CERTIFICATE OF APPROPRIATENESS

Property: 1913 B Crockett St, Lot 11A, Block 314, Shearn Addition Subdivision. The property is a vacant interior lot, subdivided into two lots, Lot A that measures 2,534 square feet (51' x 50'-4") and Lot B that measures 1,608 square feet (37'-8" x 42'-8").

Proposal: New Construction – Residence

Recommendation: Deferral

NORTH ELEVATION – FRONT FACING CROCKETT STREET

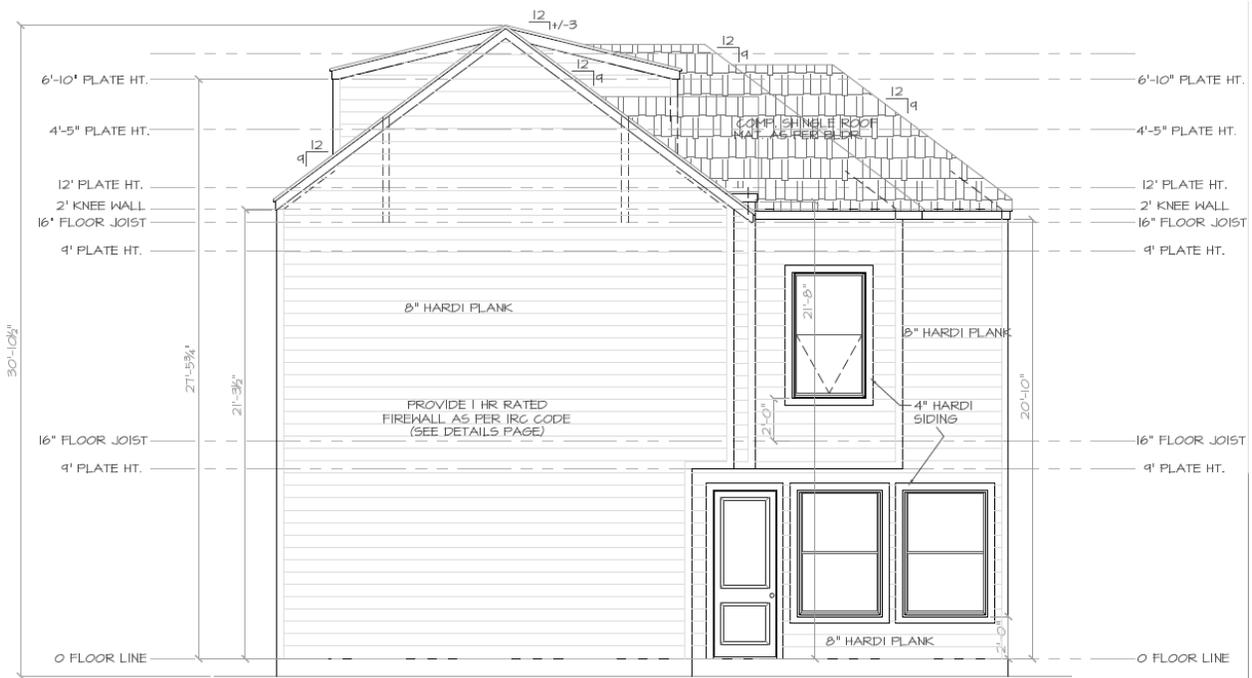
- (2) The exterior features of the new construction must be compatible with the exterior features of existing contributing structures in the context area;
8" horizontal lap cementitious siding is not an appropriate feature within the context area. Smooth-finish 4" reveal horizontal lap cementitious siding would be a more appropriate siding option.

SITE PLAN
EXISTING

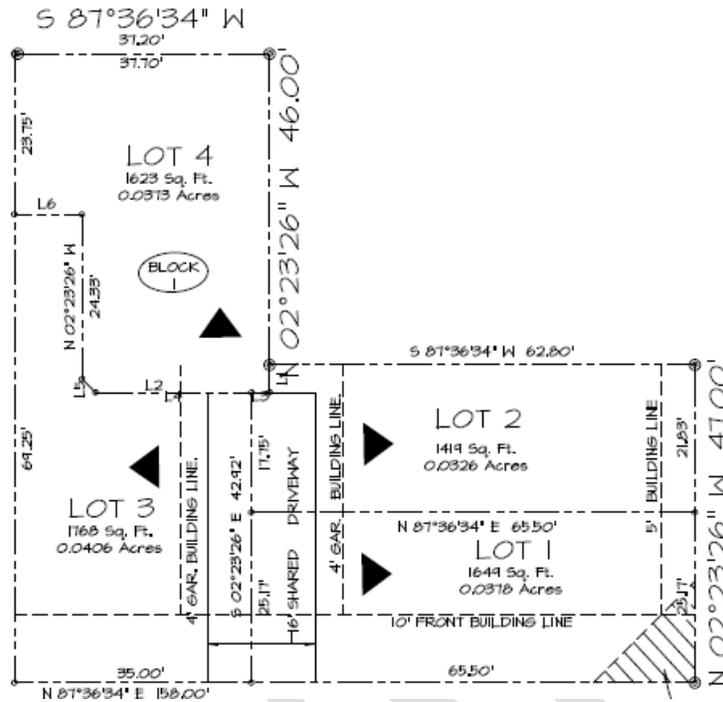
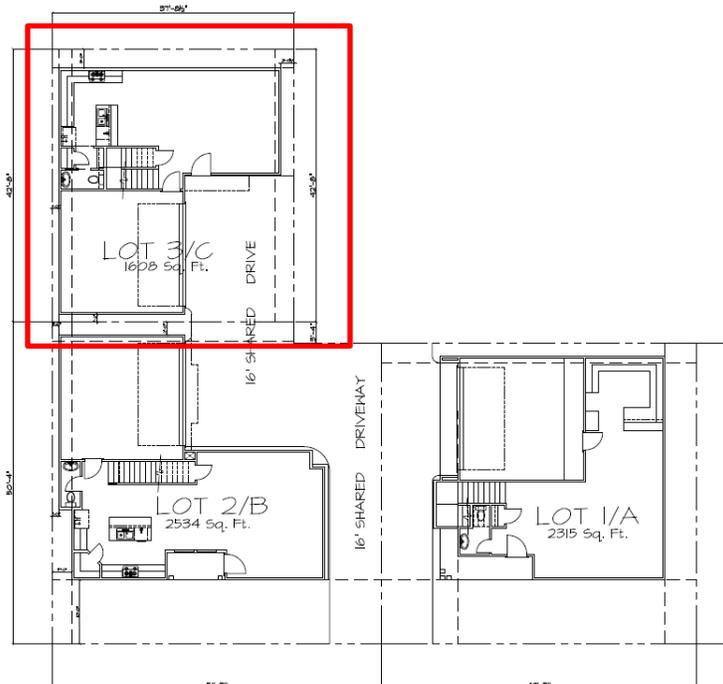
- 1.1. A site plan is required for a COA application. Each of these applications includes a drawing labeled "Site Plan". However, these purported site plans do not indicate the orientation of the proposed buildings to the surrounding streets or to each other. In addition, the elevations are listed as "left", "right", etc. instead of the usual "north", "south" etc. All this is contrary to industry standards, and makes the site plans very difficult to decipher. This needs to be addressed in order to make the proposed plans more readily understandable.

- 1.2. Given the close proximity and interrelationships of the proposed buildings with one another, a site plan should be provided that covers all the buildings in the project so that what is being proposed can be understood.

- 1.4. The historic/contributing structure at 1907 Crockett is known to encroach on its neighbor to the west (1913 Crockett). This encroachment is not shown on the site plan. This omission is significant, since it affects the actual distance that will separate the new structure at 1913 from the existing one at 1907.

- 1.5. A 10' setback from the street is noted. This is out of character for the District, where setbacks of 15 feet or more are prevalent on contributing structures. Is this permissible?
